## Architect's Supplemental Instructions

**PROJECT:** *(name and address)*  
17-13 OSU College of Med. at Hastings  
Tahlequah, OK

**ASI INFORMATION:**  
ASI Number: Bid Pack 03 - ASI 01  
Date: 4/22/19

**Bid Package 03- ASI 01 – OSU College of Osteopathic Medicine At The Cherokee Nation**

SHEET NUMBER:  
**S1.02**  
BASEMENT FOUNDATION PLAN - SECTOR 2

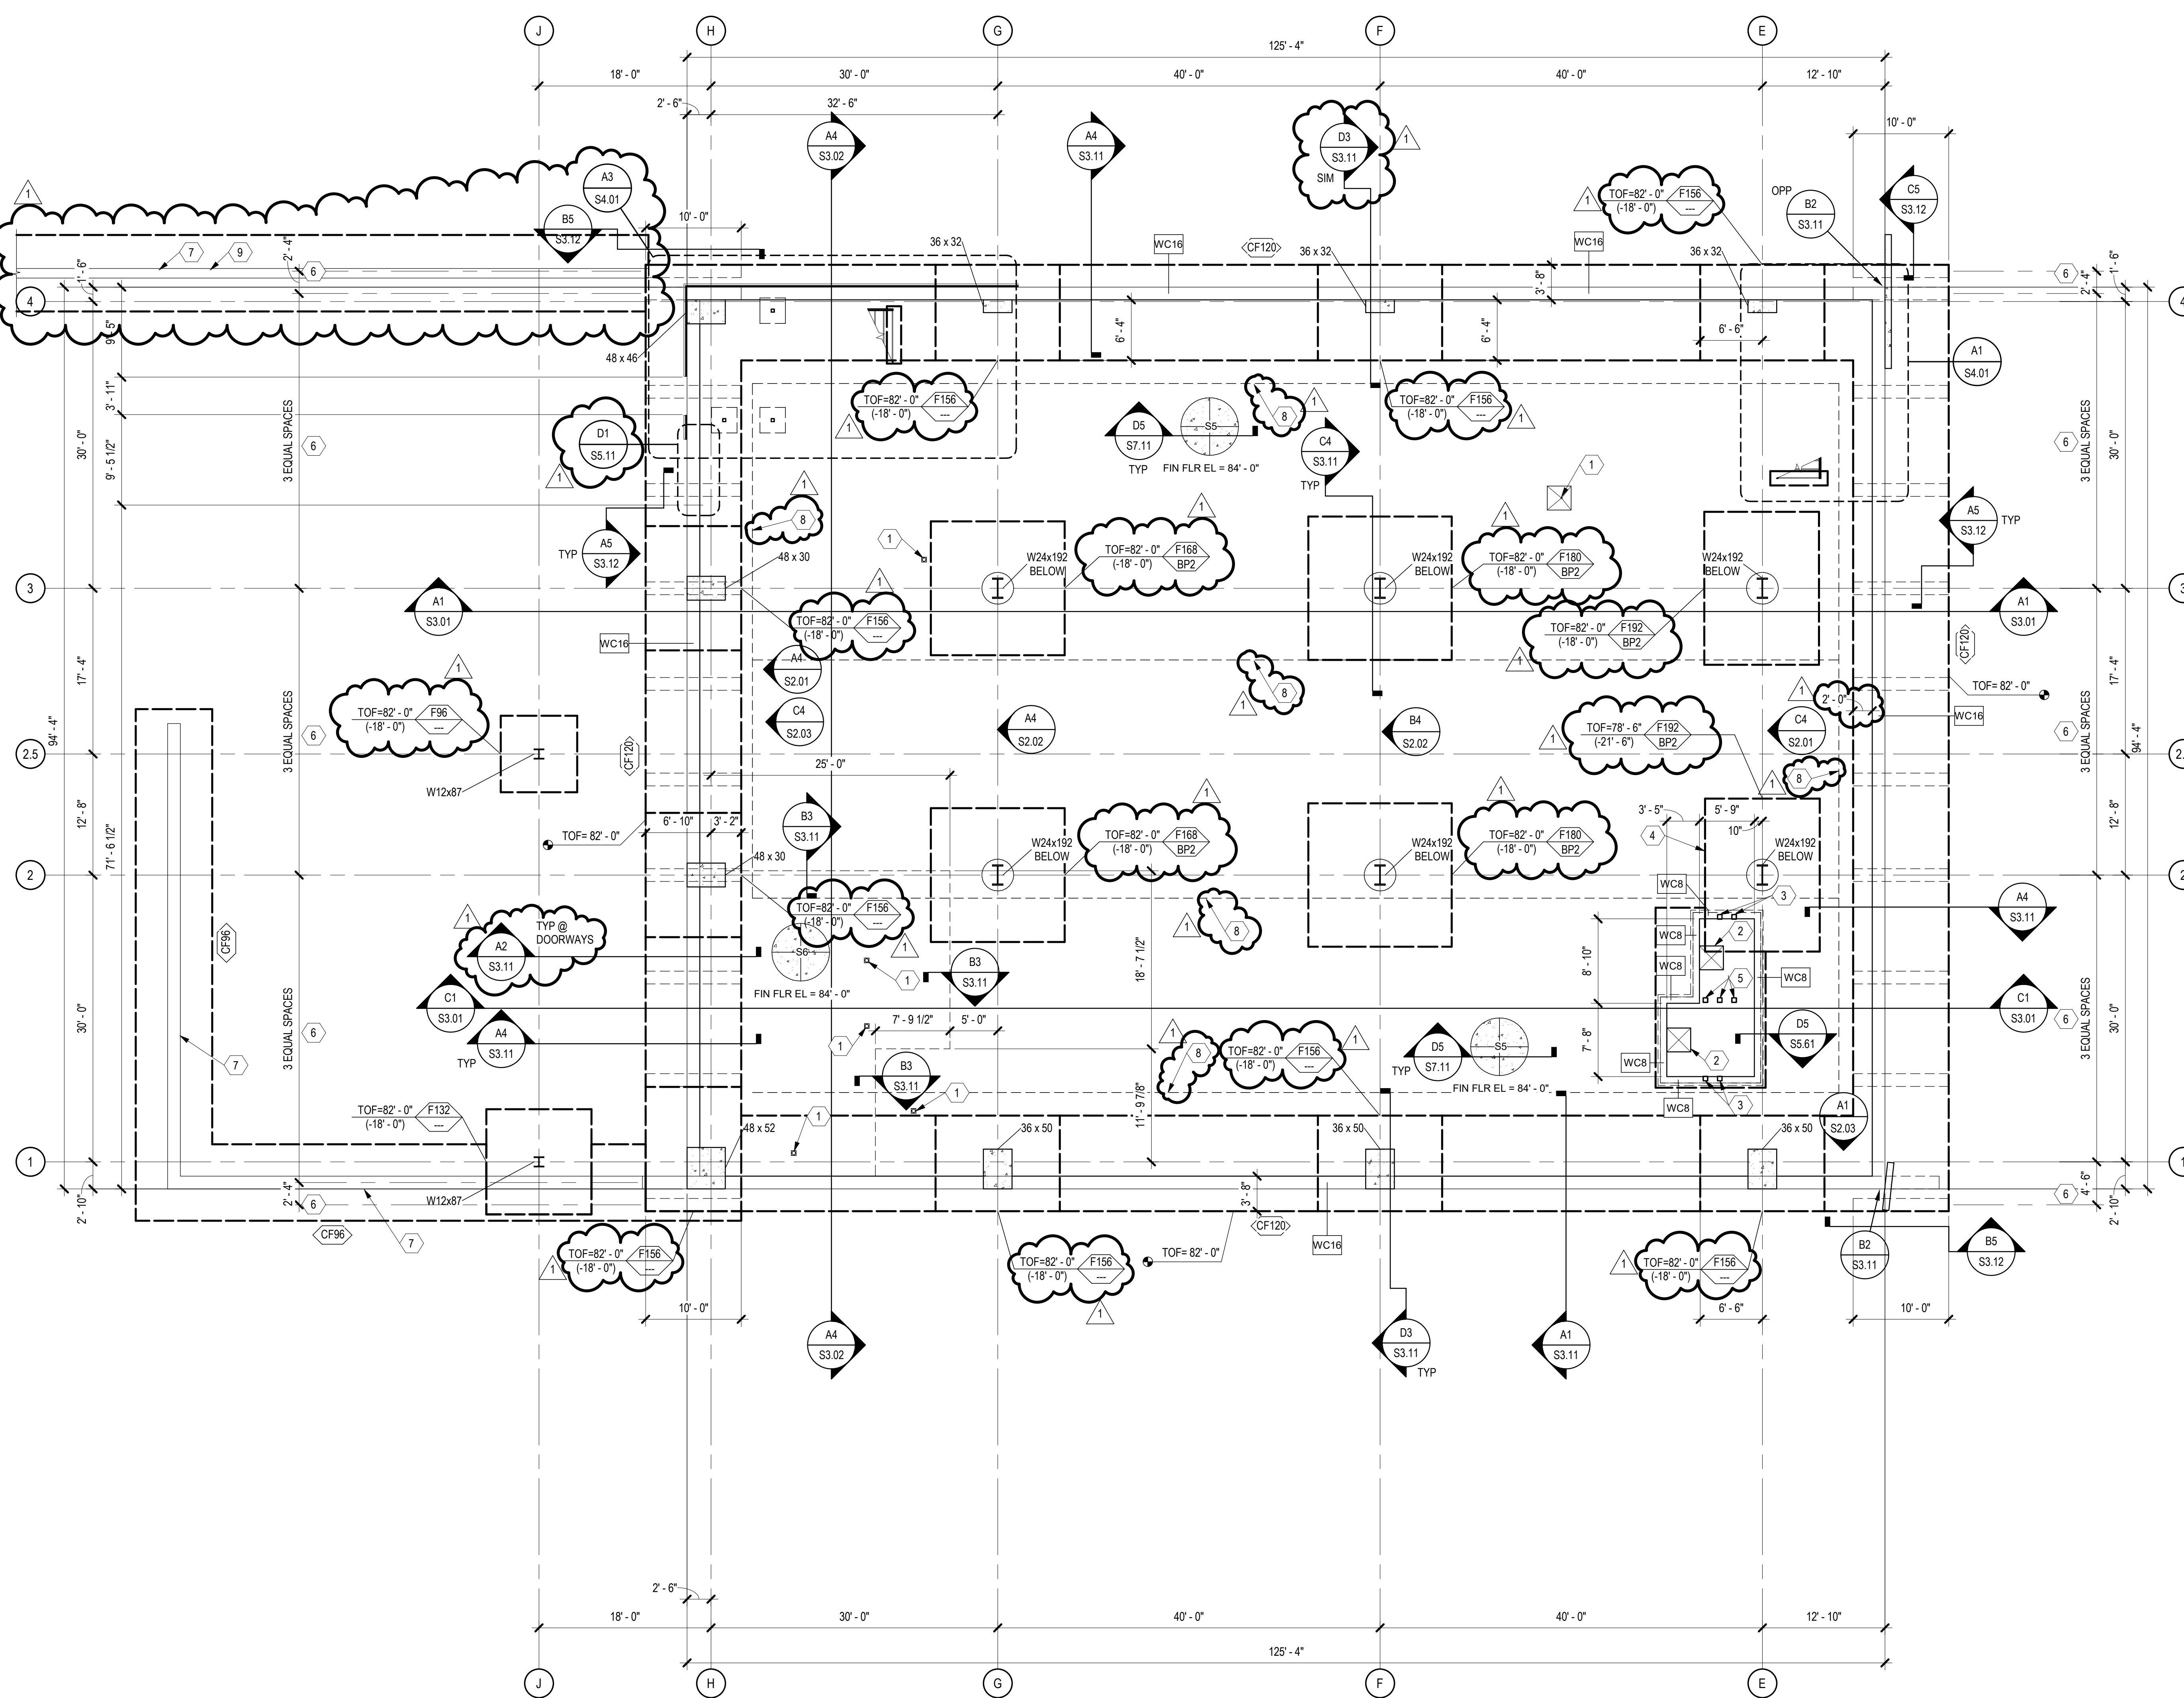
<b><u>Sheet</u></b>	<b><u>Description</u></b>
S0.02	Revised information based on the revised geotechnical report dated April 4, 2019.
S0.02	Revised deferred submittals content.
S0.03	Wall backfill and drainage schematic added (A1/S0.03).
S1.02	Site retaining wall added to plan, near Grid 4.
S1.02	Spread footing size at Grid J-2.5 revised.
S1.02	Spread footing size at Grid H-1, H-2, and H-3 revised.
S1.02	Spread footing size at Grid G-1, G-2, G-3, and G-4 revised.
S1.02	Spread footing size at Grid F-1, F-2, F-3, and F-4 revised.
S1.02	Spread footing size at Grid E-1, E-2, E-3, and E-4 revised.
S1.02	Location of continuous footing parallel to Grid E revised.
S1.02	Under slab French drain system information clarified, moved from general sheet note 9, to sheet keynote 8.
S1.02	Under slab French drain system schematically shown on plan.
S1.02	Location of continuous footing parallel to Grid E revised.
S1.02	Sheet keynote 9, for site retaining wall, added.

S1.02	Section at Grid F-4 revised from A1/S3.11 to D3/S3.11.
S1.02	Section A2/S3.11 near Grid H-2 added.
S1.02	Detail D1/S5.11 near Grid H-3 and H-4 added.
S1.11	Clarifying site wall information added along east side of building, near Grid 1.
S1.11	Site wall added near Grid A.
S1.11	Sheet keynotes 11 and 12 added.
S1.11	Spread footing size at Grid D-1 and D-4 revised.
S1.11	Top of pilaster elevation provided at Grid D-3.
S1.11	Spread footing size at Grid C-2 and C-3 revised.
S1.11	Spread footing size at Grid B-2 and B-3 revised.
S1.11	Spread footing size at Grid A.5-2 revised.
S1.11	Continuous footing sizes along Grid A, between Grid 2.5 and 4 revised.
S1.11	Continuous footing sizes along Grid 4, between Grid A and D revised.
S1.11	Section between Grid A-2.5 and 3 revised from A5/S3.11 to C5/S3.11.
S1.11	Section at Grid A.5-1 revised from A3/S3.11 to B1/S3.11.
S1.11	Section D5/S3.11 added near Grid D-1.

SHEET NUMBER:  
**S1.11**

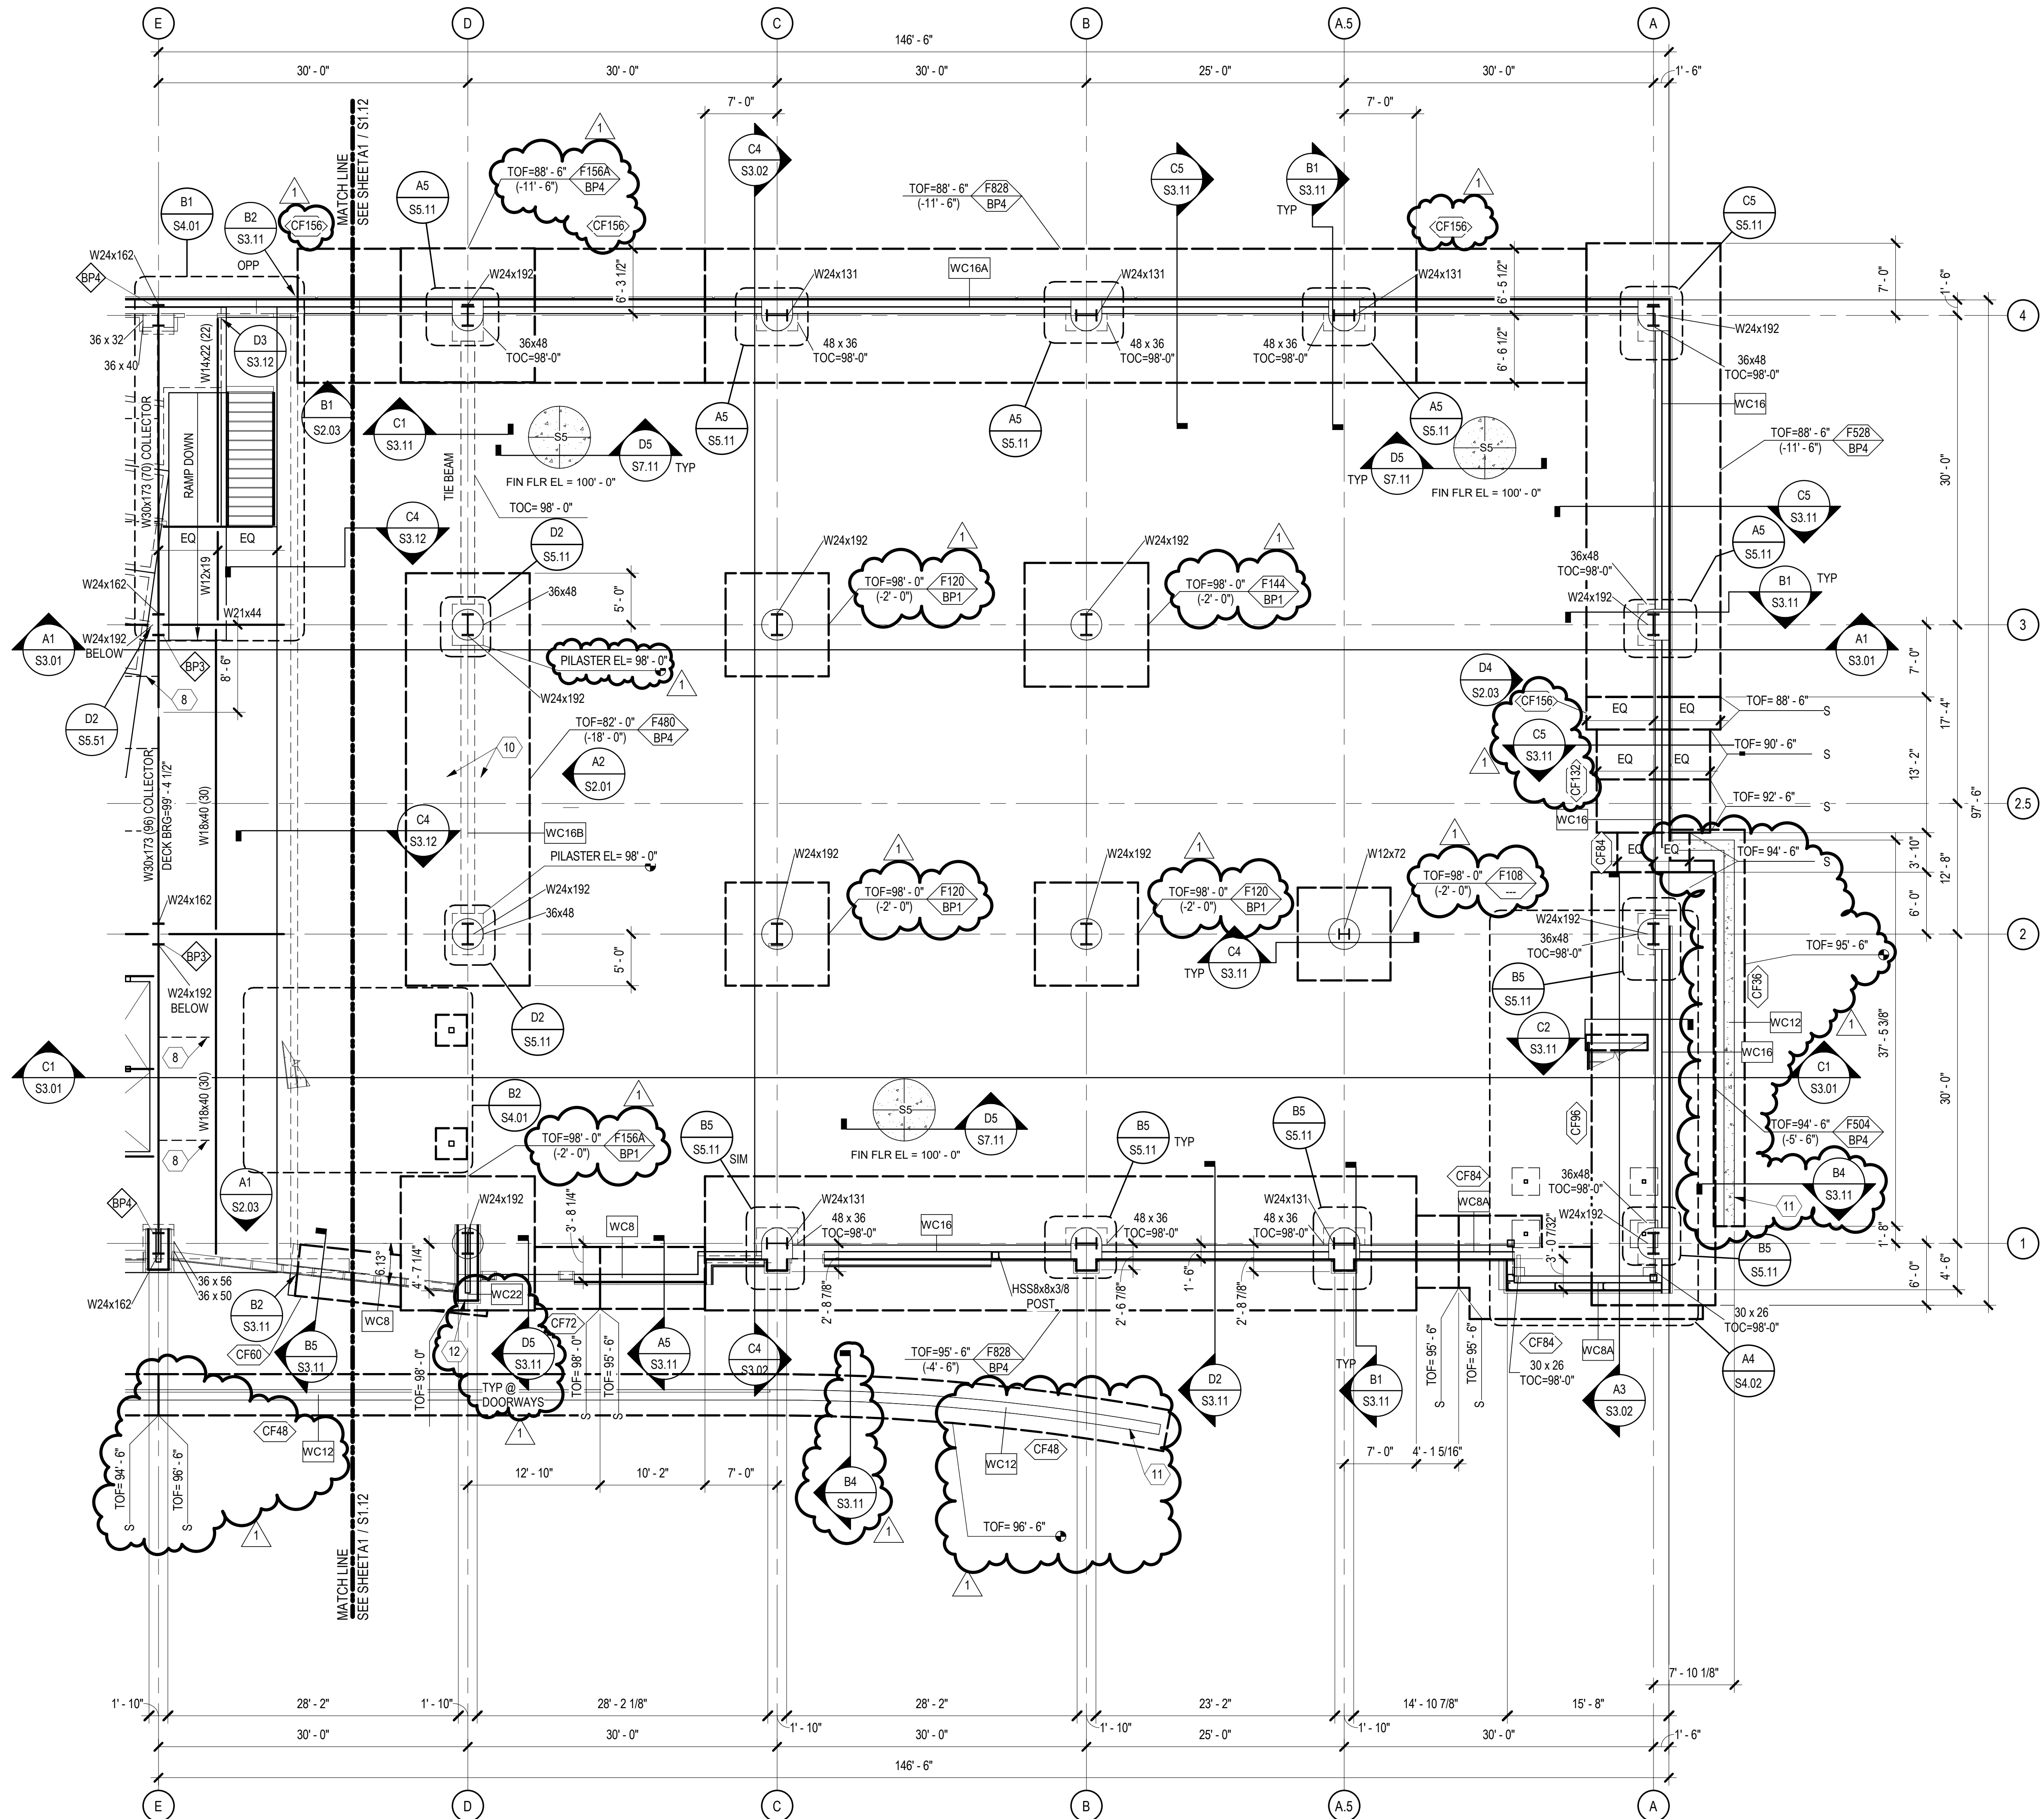
S1.11	Stud wall support clarification added at Grid D-1.
S1.12	Clarifying site wall information added along east side of building, near Grid 1.
S1.12	Detail D3/S3.12 (SIM) added along Grid H in three instances.
